Project
OLD CONNAUGHT PHASE A1 LRD

The purpose of the Stormwater Impact Assessment Report is to provide details of the Storm water elements associated with the proposed development at Lands at Allies River Road, Old Connaught, Co. Dublin.

TYPICAL SuDS TREE PIT CROSS-SECTION
SECTION C
Scale at A1 1:25
Scale at A3 1:50

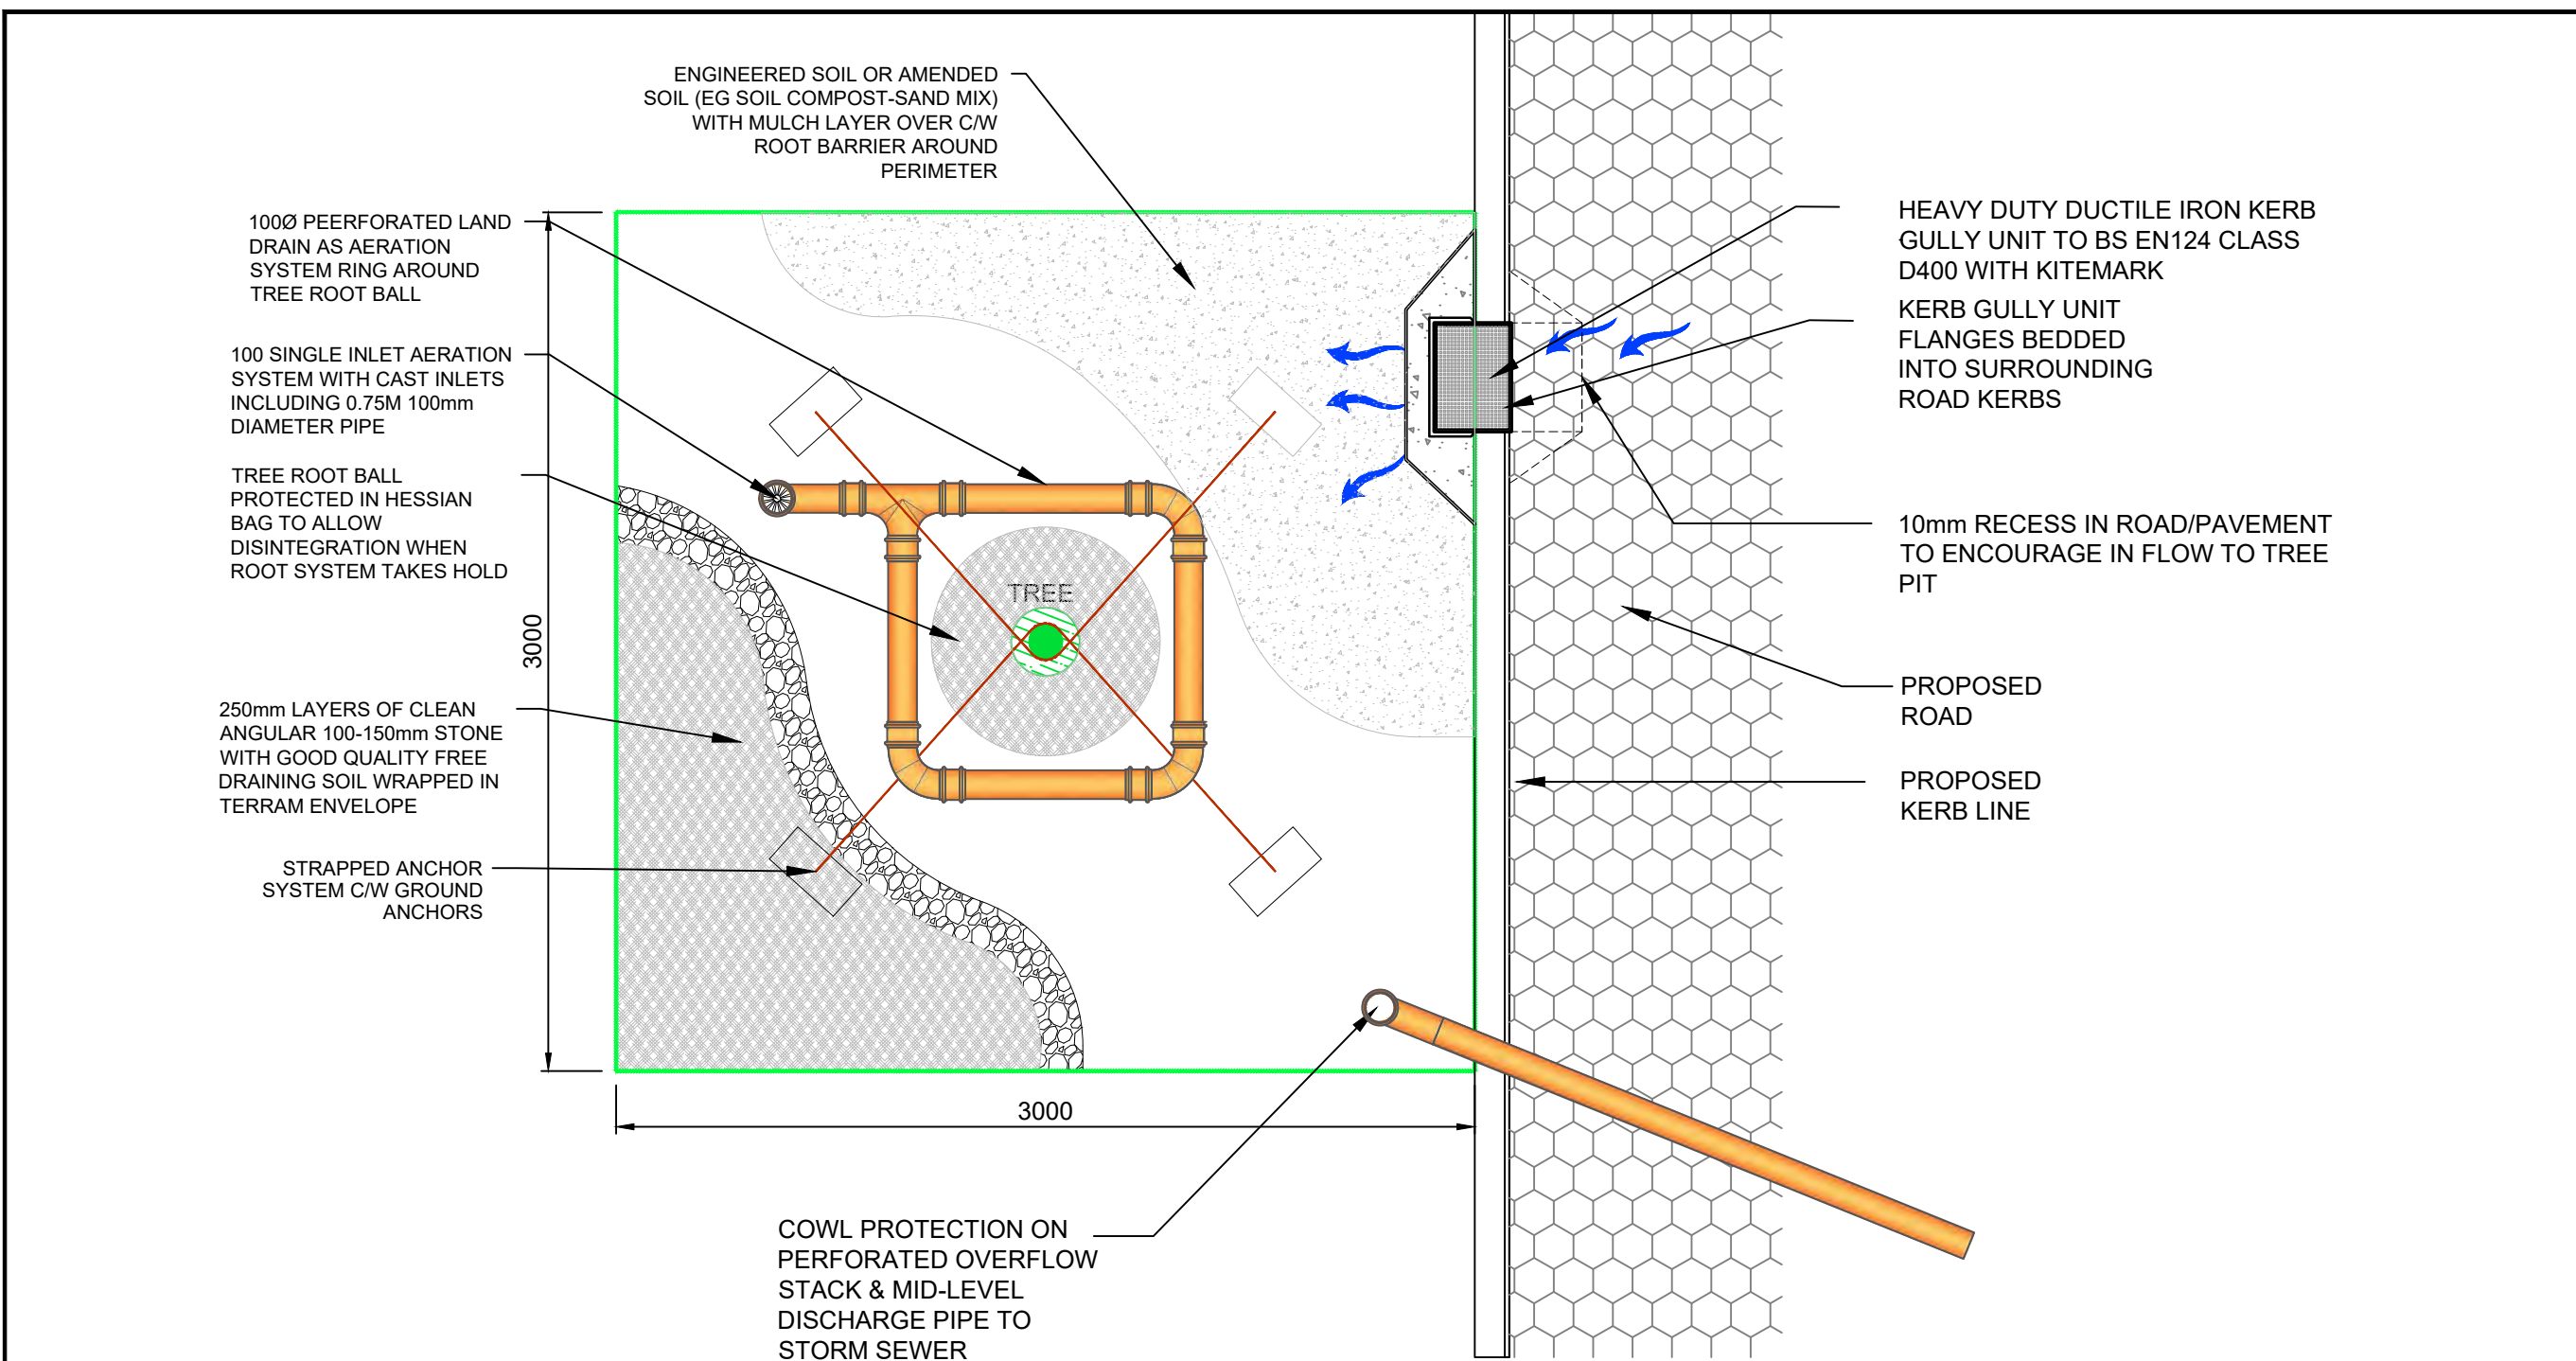
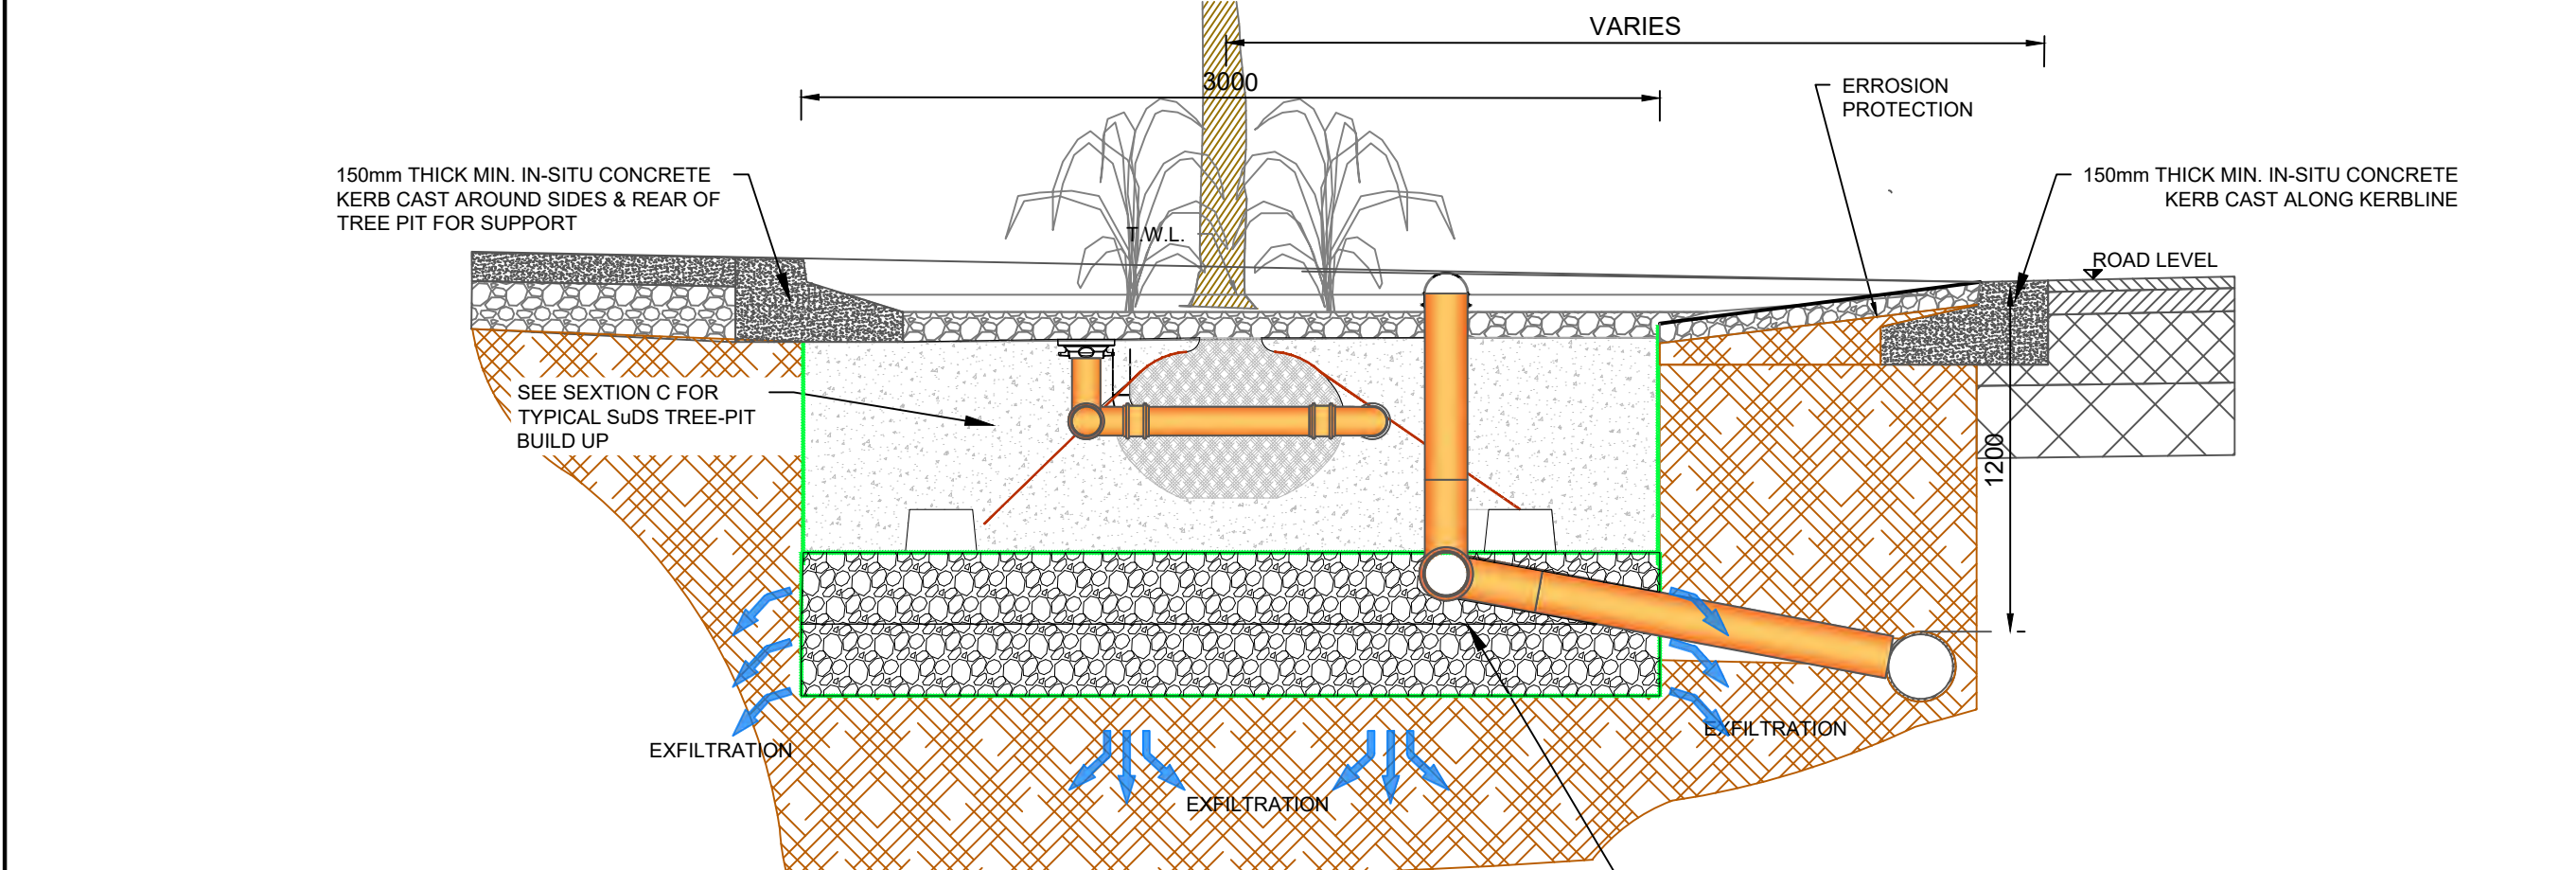
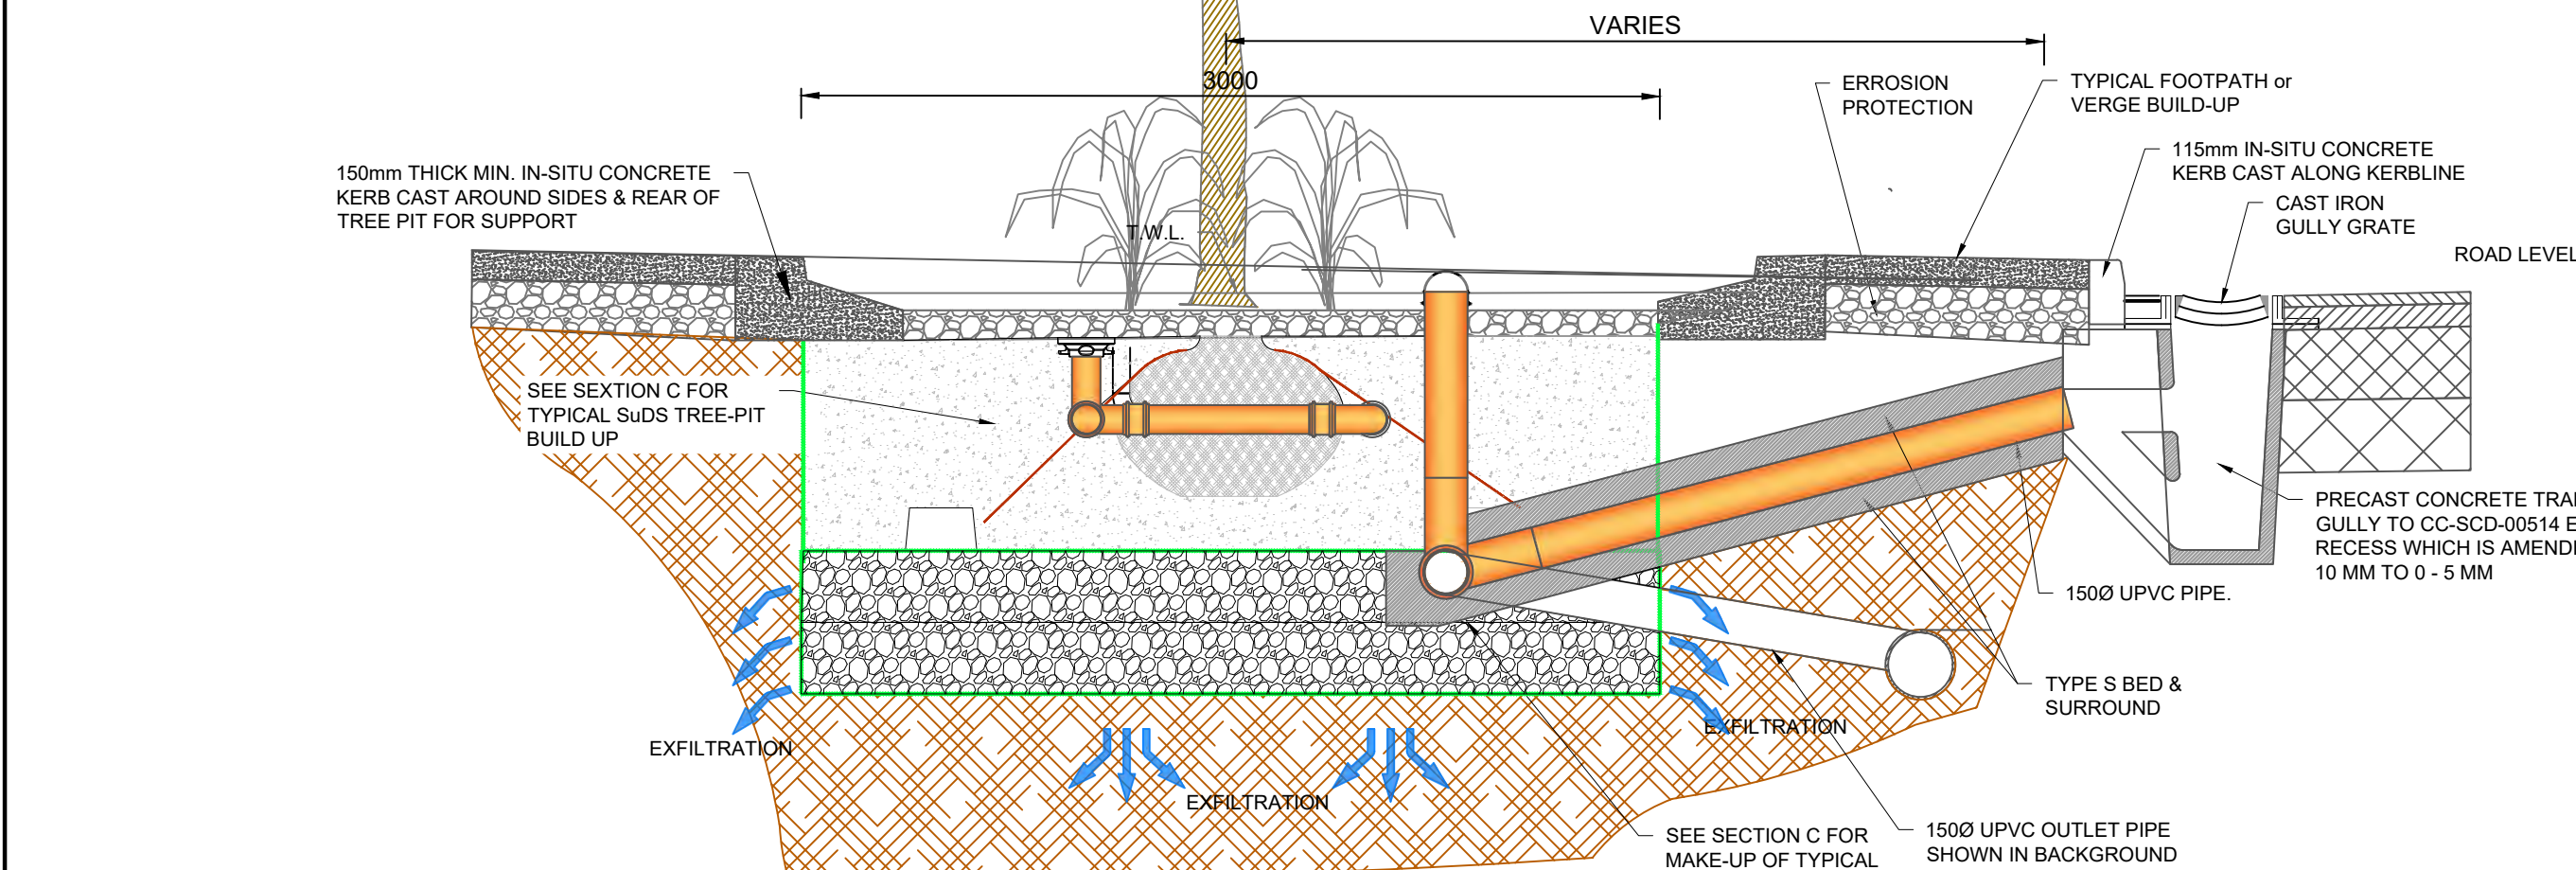
Problem: From the 'Proposed Storm Drainage Overall Plan', some tree pits appear to be standalone drainage systems with no connectivity to the surface water network. However, the Typical SuDS Details drawing indicates these features with overflow systems/outlet pipes.

2.6	Yes	Yes	The recommendation has been incorporated into the design, and the tree pit drainage connectivity and overflow arrangements are now clearly shown on the revised drawings issued with the resubmission. Please refer to drawings ATK-ZZ-ZZ-DR-CE-900501 Proposed Storm Drainage Layout - Sheet 1 ATK-ZZ-ZZ-DR-CE-900502 Proposed Storm Drainage Layout - Sheet 2	Yes
